Access Compliance Report Public Rights-of-Way (Curb Ramps)

Intersection ID: 47660Main Street: FENWAY_DRCross Street: EBBETS_RDLocation:SEADA ID: 832FF5DCE118Ramp Type: PerpInitial Pass/Fail: FailOverall Compliance: NoSeverity Score: 8.75

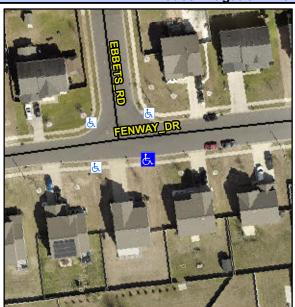
Field Measurements/Component Compliance								
Compliance Description		Data	Comp	liance Description	Data			
	N/A	Ramp Length (in)	44.5	Yes	Ramp Slope (%)	7.4		
	No	Ramp Width (in)	47.0	Yes	Ramp XSlope (%)	1.2		
	N/A	Flare Type LT	N/A	N/A	Flare Type RT	N/A		
	N/A	Flare Slope LT (%)	N/A	N/A	Flare Slope RT (%)	N/A		
	N/A	Flare Traversable LT?	N/A	N/A	Flare Traversable RT?	N/A		
	N/A	Landing Length (in)	N/A	N/A	DWS Provided?	N/A		
	N/A	Landing Width (in)	N/A	N/A	DWS Contrast?	N/A		
	N/A	Landing Slope (%)	N/A	N/A	DWS Length (in)	N/A		
	N/A	Landing X Slope (%)	N/A	N/A	DWS Full Width?	N/A		
	N/A	Landing Curb? (Y/N)	N/A	N/A	DWS Offset (in)	N/A		
	N/A	Shared Landing?	N/A					
	N/A	Gutter Ponding?	N/A	N/A	Gutter Slope (%)	N/A		
	N/A	Gutter Lip Ht (in)	N/A	N/A	Gutter X Slope (%)	N/A		
	N/A	Painted X Walk1?	No	N/A	Painted X Walk2?	N/A		
		X Walk 1 Direction	To N		X Walk 2 Direction	N/A		
	N/A	X Walk 1 Width (in)	N/A	N/A	X Walk 2 Width (in)	N/A

X Walk 1 Slope (%)	3.0		X Walk 2 Slope (%)	N/A		
		X Walk 1 X Slope (%)	1.4		X Walk 2 X Slope (%)	N/A		
	N/A	Ramp inside XWalk1?	N/A	N/A	Ramp inside XWalk2?	N/A		
		Road Slope (%)	N/A	N/A	Clear Space?	N/A		
		Road X Slope (%)	N/A	N/A	Clear Space to XWalk (in)	N/A		
	N/A	Any Obstructions?	N/A	N/A	Storm Grate/Utility Hazard?	N/A		
		Obstruction Type			Storm Grate/Utility Type			
			N/A			N/A		
				Yes	Surface Condition? (G/P)	Good		
	1383000

Possible Solutions:							
Remove & Replace Entire Ramp.							
Company Nata as							
Surveyor Notes:							
N/A							
PROW/ADA:							
R304.5.1
